SUBJECT: Responds to 980123 RAI re NRC GL 87-02, "Verification of Seismic Adequacy of Mechanical & Electrical Equipment in Operating Reactors, Unresolved Safety Issue (USI) A-46."

AEP:NRC:1040G

Donald C. Cook Nuclear Plant Units 1 and 2
RESPONSE TO REQUEST FOR ADDITIONAL INFORMATION (RAI)-NRC GENERIC
LETTER 87-02, "VERIFICATION OF SEISMIC ADEQUACY OF MECHANICAL AND
ELECTRICAL EQUIPMENT IN OPERATING REACTORS, UNRESOLVED SAFETY
ISSUE (USI) A-46." (TAC NOS. M69437 AND M69438)

RESPONSE TO REQUEST FOR ADDITIONAL INFORMATION

COMPARISON OF 5% DAMPED
IN-STRUCTURE RESPONSE SPECTRA
TO 1.5 TIMES THE BOUNDING SPECTRUM

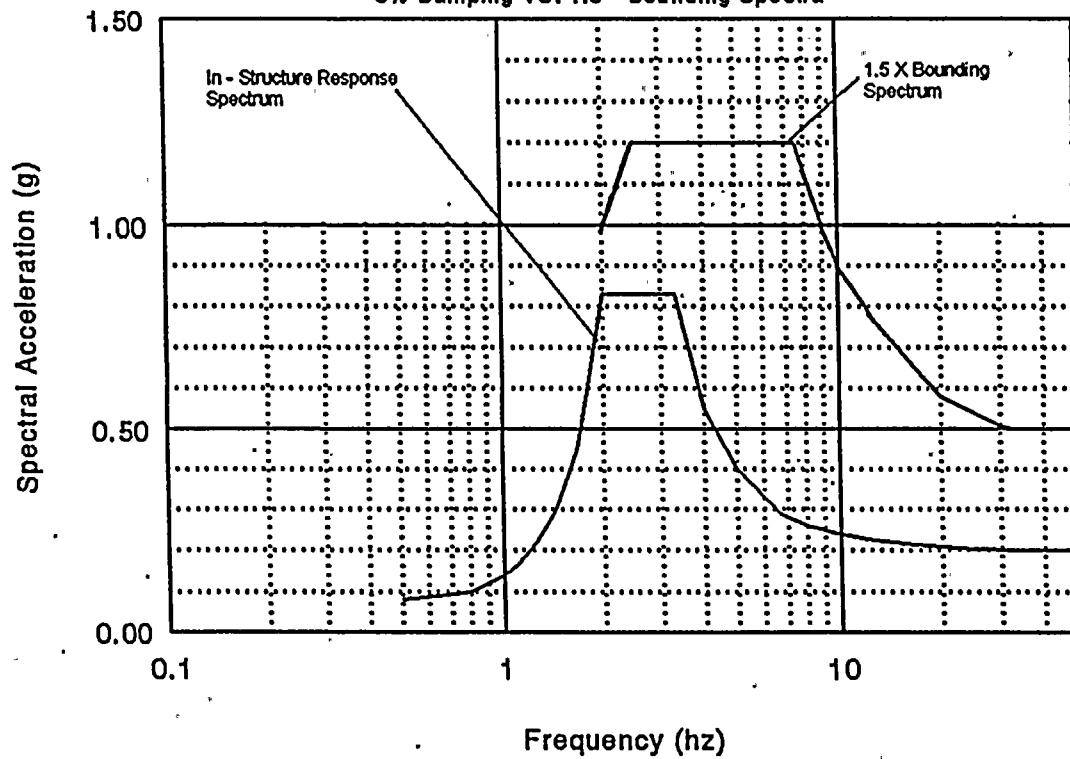
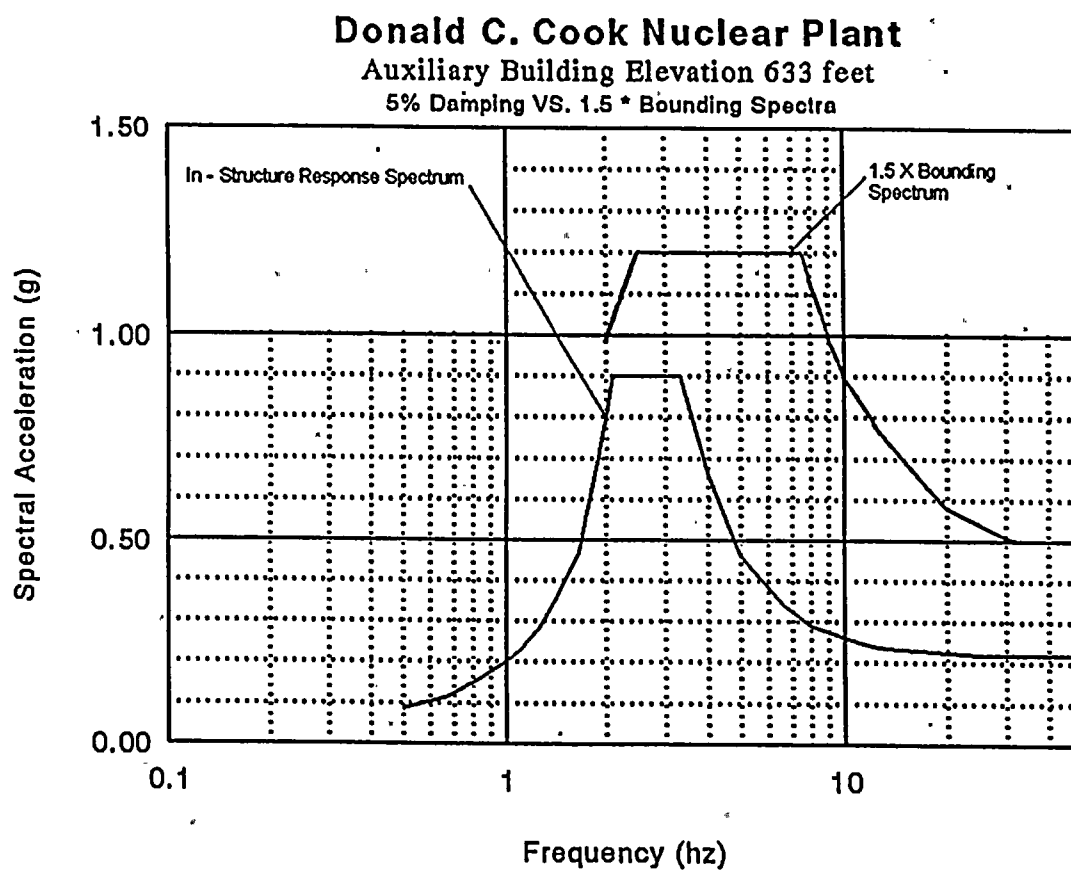
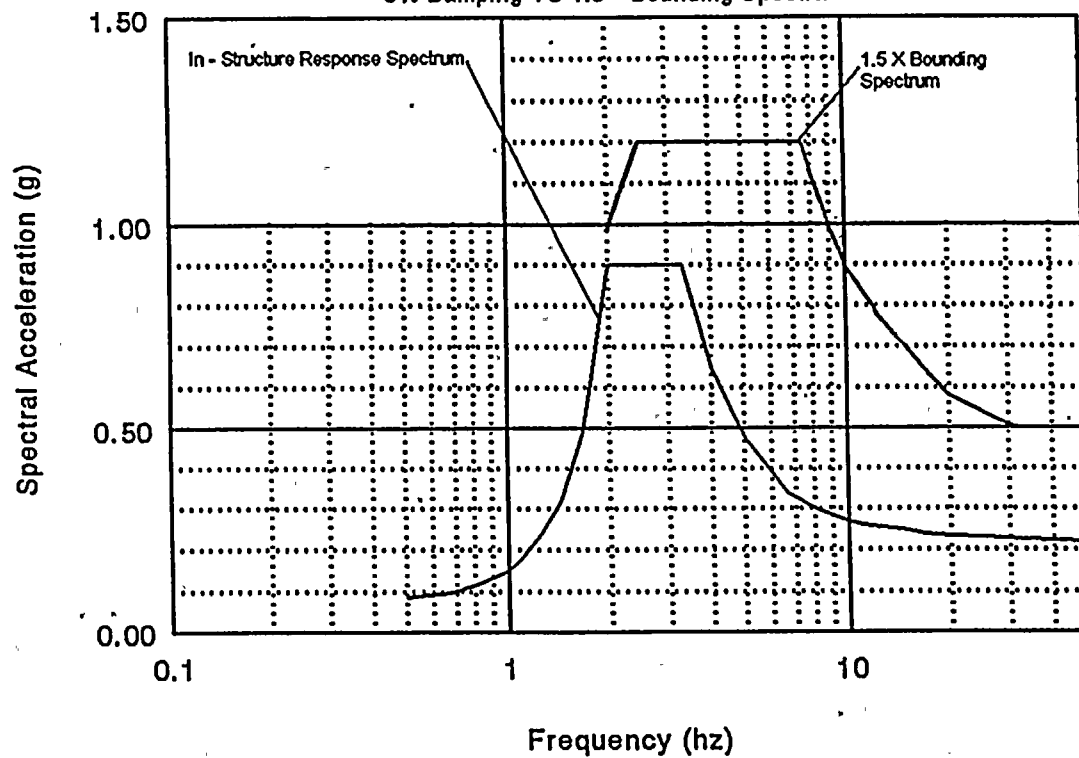
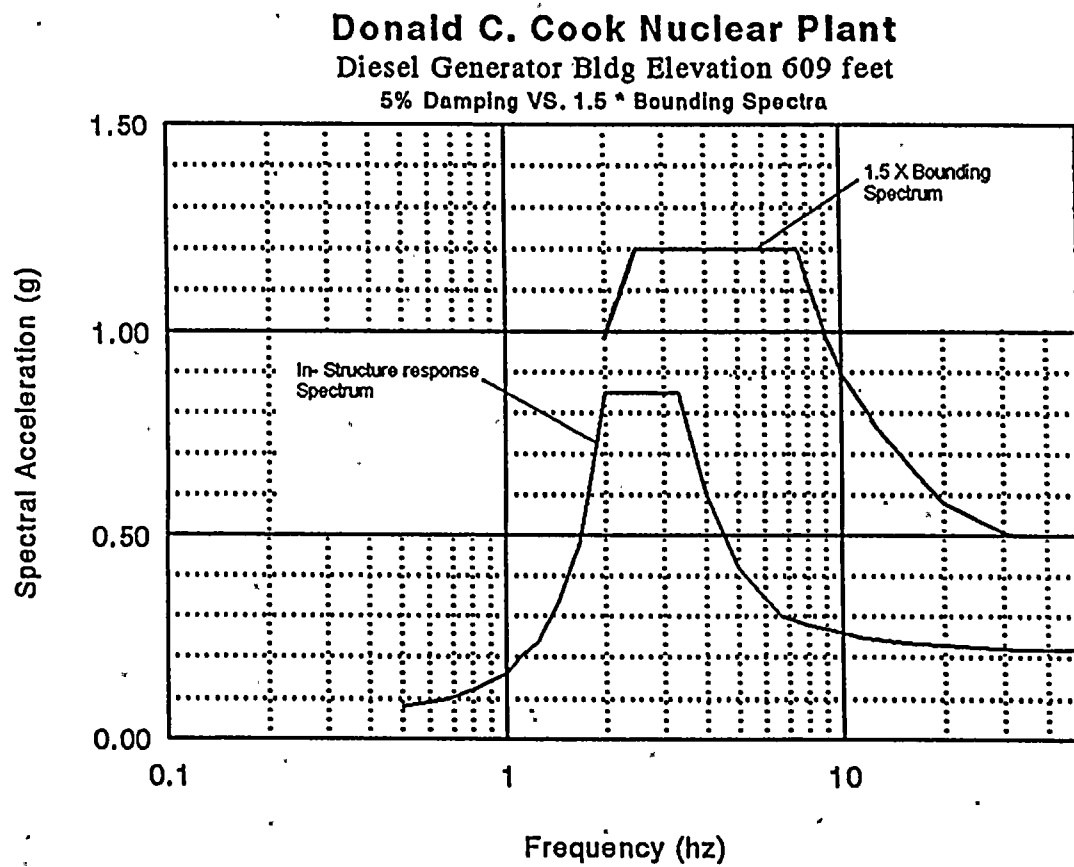
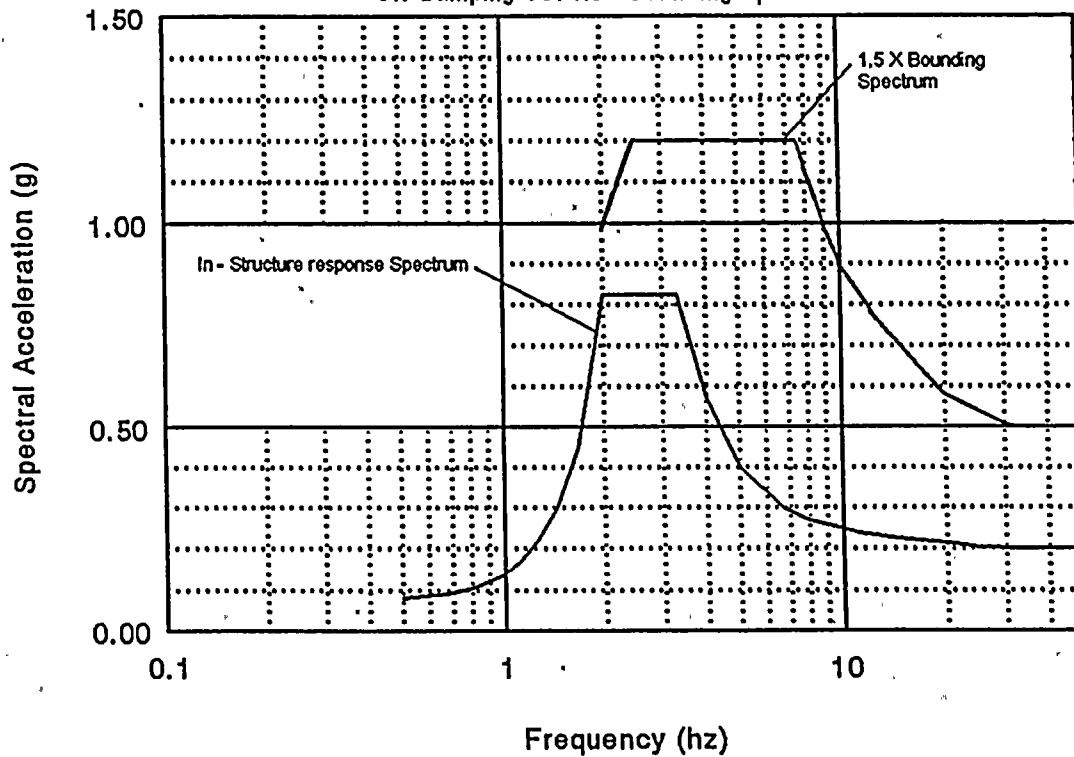
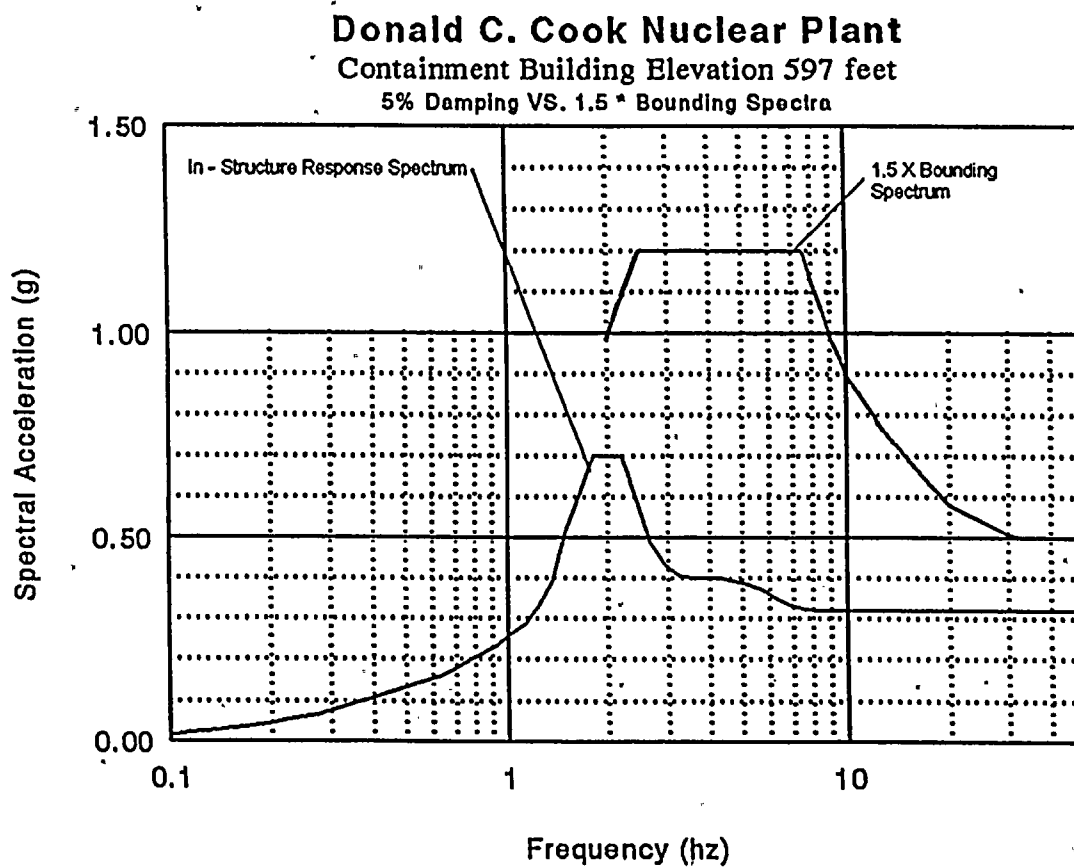
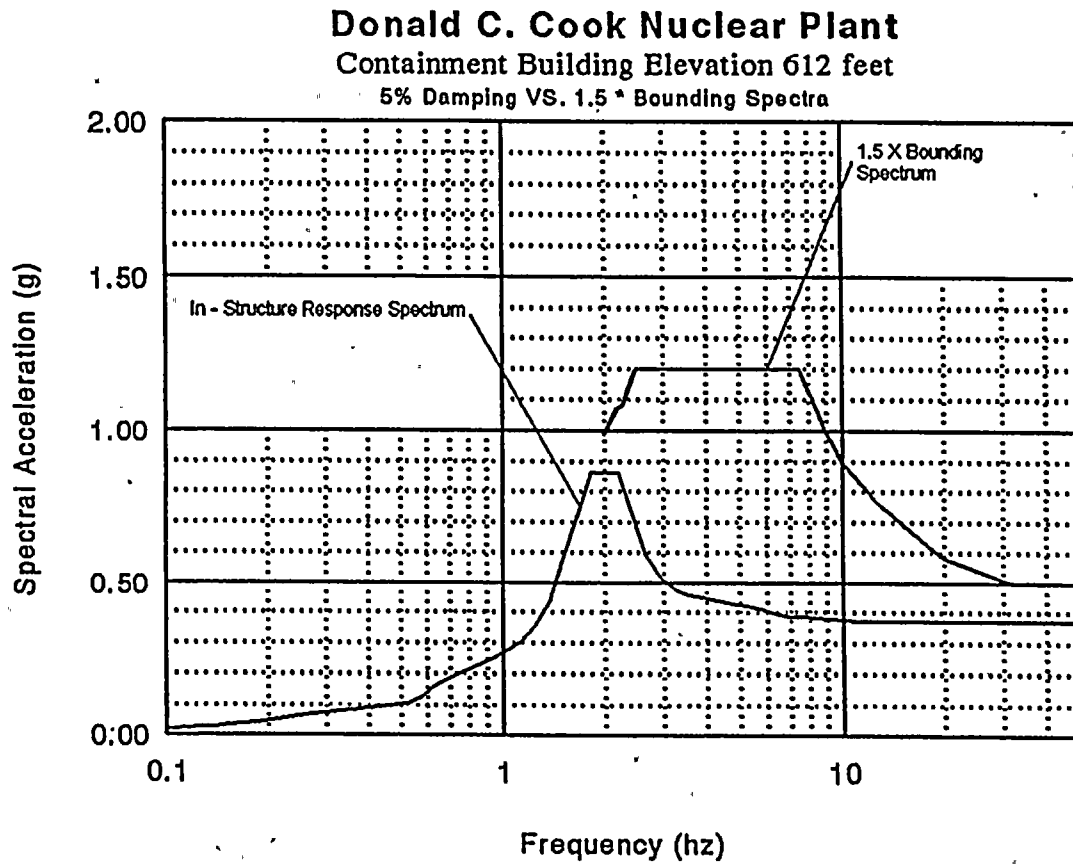
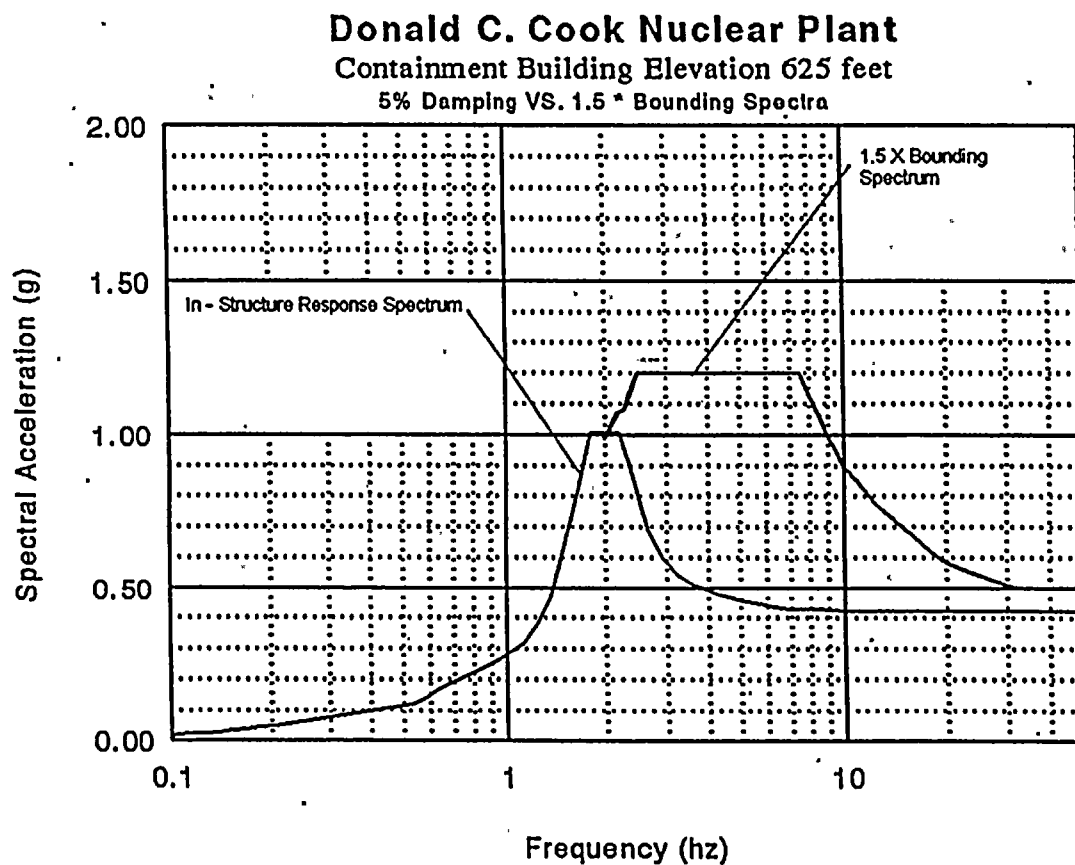
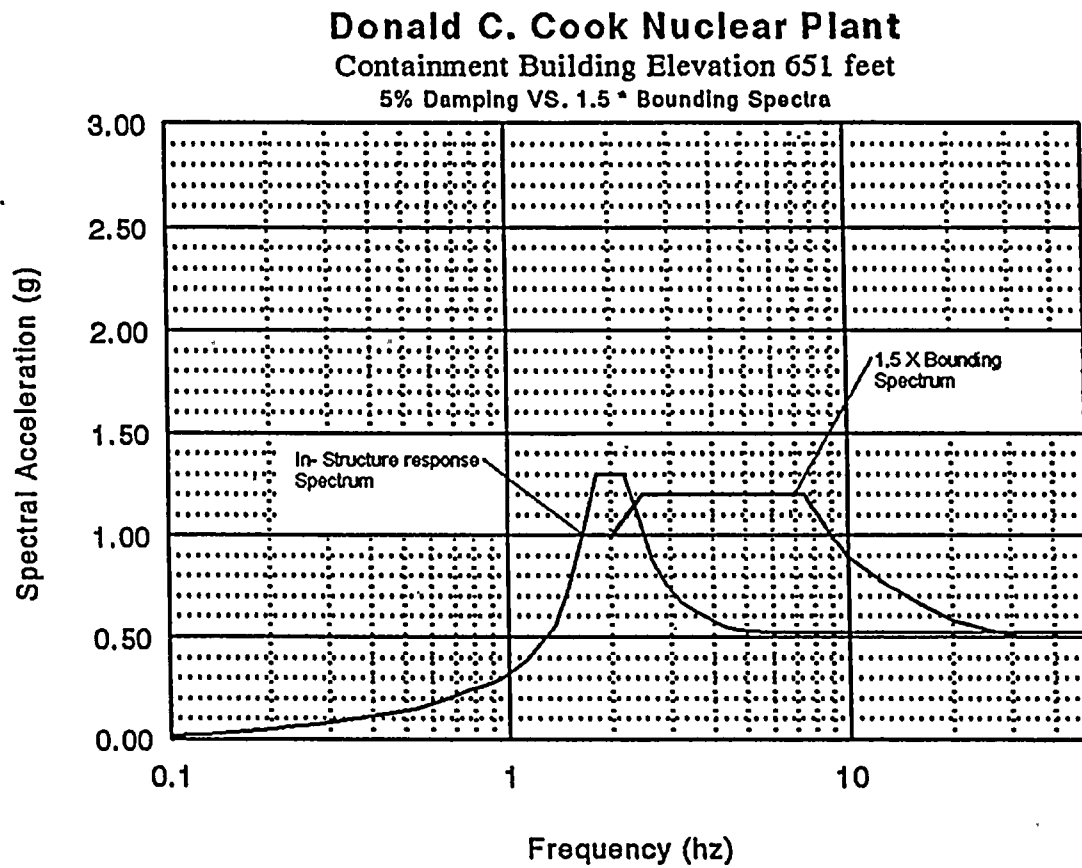
3. Referring to the in-structure response spectra provided in your 120-day-response to the NRC's request in Supplement No. 1 to Generic Letter 87-02 dated May 22, 1992, the following information is requested:

- a) Identify structure(s) which have in-structure response spectra (5% critical damping) for elevations within 40-feet above the effective grade, which are higher in amplitude than 1.5 times the SQUG Bounding Spectrum.

- c) *For the structure(s) identified in Item (a) above, provide the in-structure response spectra designated according to the height above the effective grade. If the in-structure response spectra identified in the 120-day-response to Supplement No. 1 to the Generic Letter 87-02 was not used, provide the response spectra that were actually used to verify the seismic adequacy of equipment within the structures identified in Item (a) above. Also, provide a comparison of these spectra to 1.5 times the Bounding Spectrum.*

Grade elevation for the Cook Nuclear Plant is at El. 608'. Figures 1 to 9 (Appendix A of this submittal) provide a comparison of the 5% damped in-structure response spectra to 1.5 times the Bounding Spectrum (for all elevations within about 40' above grade). These include Elevations 587', 633', and 650' in the Auxiliary Building, Elevation 609' in the Diesel Generator Building, Elevation 591' in the Turbine Building, and Elevations 597', 612', 625' and 651' in the Containment Building. As shown in the figures, 1.5 times the Bounding Spectrum envelopes the 5% damped in-structure response spectra for the frequency range of interest (2 Hz. to 33 Hz.) with the only exception being Elevation 651' in Containment, where the in-structure response spectrum is larger than 1.5 times the Bounding Spectrum from 2 to 2.5 Hz and from 29 Hz. and above.

Because 1.5 times the Bounding Spectrum envelopes the 5% damped in-structure response spectra, with the exception noted above, the use of GIP Method A was determined to be acceptable for use at Cook Nuclear Plant.

The comparisons requested of 1.5 times the bounding spectrum to the in-structure response spectrum is provided in Figures 1 to 9 (Appendix A) as discussed in response to question number 3.a) above. The in-structure response spectra submitted by the Cook Nuclear Plant in the 120-day response to Supplement No. 1 of GL 87-02 were used to verify the seismic adequacy of equipment when Method A was not used. No other spectra were developed for use in the USI A-46 program at Cook Nuclear Plant Units 1 and 2.
